**Project Prospectus – Dorsey Mill Road Bridge over I-270**

**Completed: 04/21/2015**

**Summary**

**Figure 3 – Proposed Bridge Typical Section over I-270**

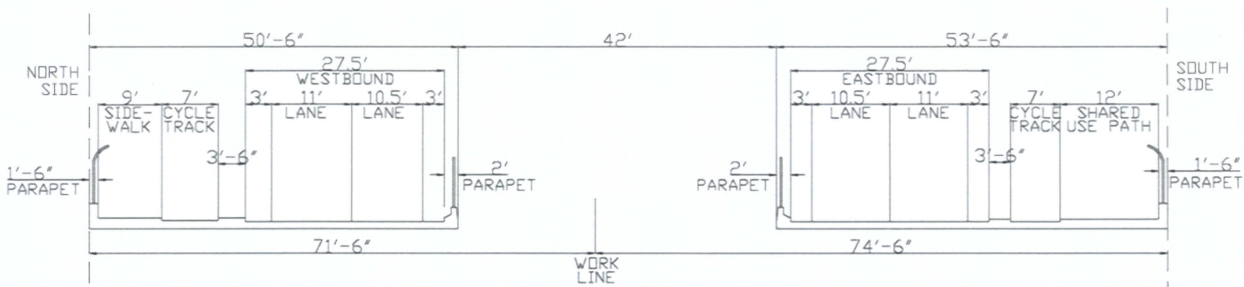
1. We are concerned that a phased construction of the bridge, with the roadway spans being constructed before the CCT, could result in an unnecessarily wide bridge that would be more costly but less attractive.

2. Consider reducing the three-foot width of the shoulders next to the parapets to one foot; eliminating the outside shoulders; and reducing the distance between the sidewalk/shared use path and the right-of-way line to two feet. This space could be used to increase the width of buffer between the travel lanes and the cycle track and/or to provide space for planter boxes on the bridge, either between the cycle track and roadway or on the outsides of the bridge, similar to the 23<sup>rd</sup> Street Bridge over E Street NW in the District, with the landscaping helping knit the two sides of Germantown together.

3. The cycle track should be at the same level as the top of curb adjacent to the travel lane so as to not trap stormwater runoff. The curb between the cycle track and the sidewalk should be mountable.

**Staff does not at this time support the bridge construction being accomplished in two phases as proposed – the roadway spans before the CCT is constructed and the middle span constructed later as part of the CCT project.** The concern is that this phasing approach may ultimately result in a wider than necessary bridge in order to provide the necessary inside barriers on each of the two spans in the first phase. A wider than necessary bridge may also provide poor aesthetics by having unnecessary “dead space” in the bridge. Staff
